Your Ref
Y/26/15/HH
Our Ref
PLAN-009379
Date
09/04/2015

Proposal: 1 No. annexe building providing ancillary accommodation to main house.

Site: The Old Thatched Cottage, North End Road, Yapton, BN18 0DL.
Y/26/15/HH

Southern Water MapGuide Browser

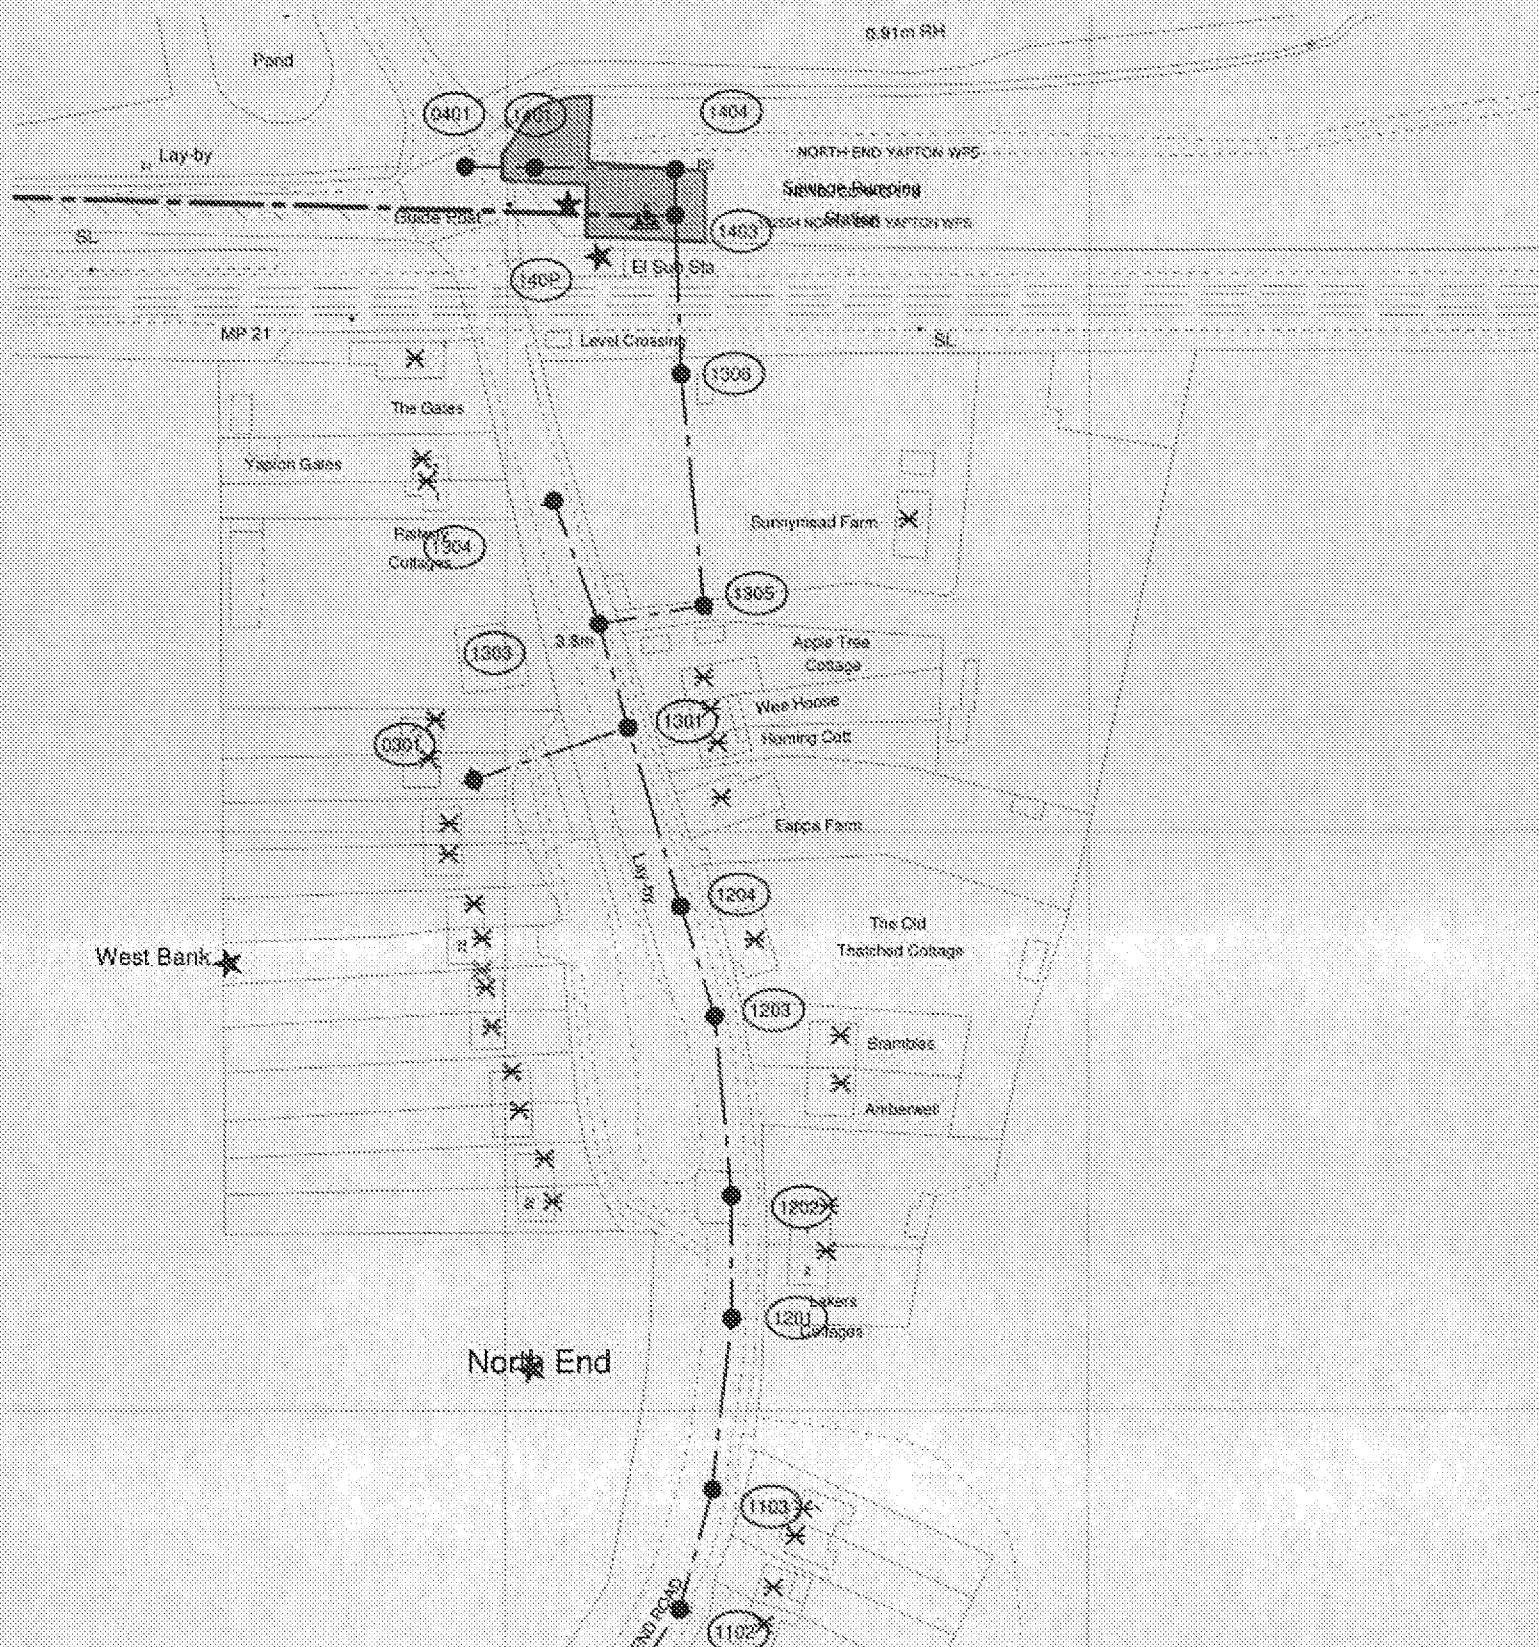
Our initial investigations indicate that there are no public surface water sewers in the area to serve this development. Alternative means of draining surface water from this development are required. This should not involve disposal to a public foul sewer.

Due to changes in legislation that came in to force on 1st October 2011 regarding the future ownership of sewers it is possible that a sewer now deemed to be public could be crossing the above property. Therefore, should any sewer be found during

construction works, an investigation of the sewer will be required to ascertain its condition, the number of properties served, and potential means of access before any further works commence on site. The applicant is advised to discuss the matter further with Southern Water, Sparrowgrove House, Sparrowgrove, Otterbourne, Hampshire SO21 2SW (Tel: 0330 303 0119) or www.southernwater.co.uk.
